**Subject: Response to Portion of NRC Request for Additional Information Letter No. 97 Related to ESBWR Design Certification Application - Reactor Water Cleanup/Shutdown Cooling System - RAI Number 5.4-59**

**Response to Portion of NRC Request for  
Additional Information Letter No. 97  
Related to ESBWR Design Certification Application  
Reactor Water Cleanup/Shutdown Cooling System  
RAI Number 5.4-59**

**NRC RAI 5.4-59:**

**Figure 5.4-59-1. Schematic of RWCU/SDC System Flowpath**

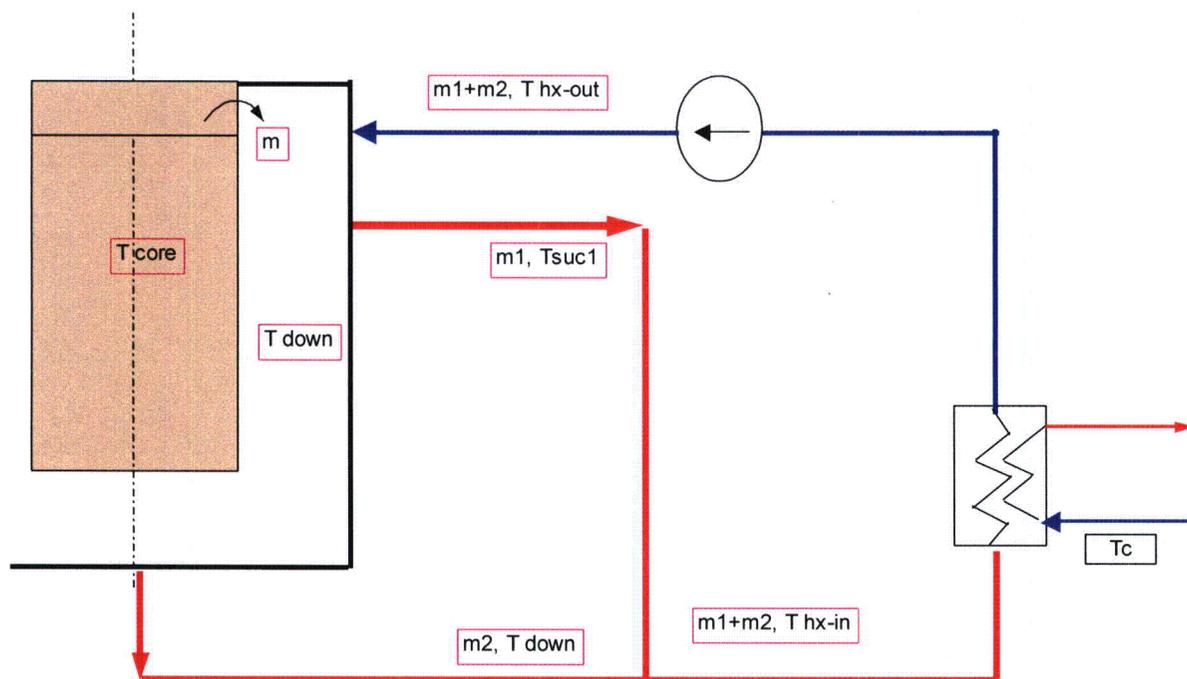
- (A) Provide a drawing of the ESBWR vessel showing the elevations of the feedwater (FW) nozzles and the RWCU/SDC piping penetrations inside and outside the shroud*
- (B) Include a discussion in the DCD regarding vessel level for normal RWCU/SDC operation in all modes, including Modes 4, 5, and 6.*
- (C) Perform a calculation demonstrating under what temperatures and levels the RWCU/SDC system can adequately remove decay heat in Modes 4, 5, and 6 (with the RPV head installed) including any minimum and maximum temperatures and levels*
- (D) Include a discussion in the DCD regarding RWCU/SDC flow and mixing within the vessel and within the shroud*
- (E) Address thermal-hydraulic uncertainty*
- (F) Address the impact on the ESBWR shutdown PRA*

- (C)** An analytical calculation has been performed for Modes 4 and 5. Mode 6 is not analyzed because the RPV has been cooled for this mode. The starting point for this calculation is 0.5 hour after control rod (CR) insertion when the RPV is at the rated temperature. The fluid flow within the RPV is assumed to be single liquid phase flow. The heat rejection (loss) through the RPV outer wall to the drywell is not considered. It is noted that these two assumptions are conservative for the current application. The RPV is modeled as two nodes: the core region and the

downcomer region, as shown in Figure 5.4-59-1. The core region node includes the fuel, vessel metal mass, and water inside the shroud. The downcomer region includes the water outside of the shroud and the water in the lower plenum. As mentioned in the response to Item B, the RPV water level is higher than the first stage steam separator drain when the RWCU/SDC System starts operating. The calculation is based on the water level that is equal to the first stage of steam separator drain. Any level higher than this level would not have an impact on the natural circulation core flow rate, and thus would not affect the RWCU/SDC characteristics. The schematic of the flow path for the current calculation is shown in Figure 5.4-59-1. The following equations are solved together to obtain the RPV temperature response: 1) energy balance equations for the core node; 2) energy balance equations for the downcomer node; 3) flow mixing in the mid-vessel region; 4) heat transfer equation in the NRHX; and 5) the momentum conservation equation in the downcomer and core nodes to solve the core flow rate.
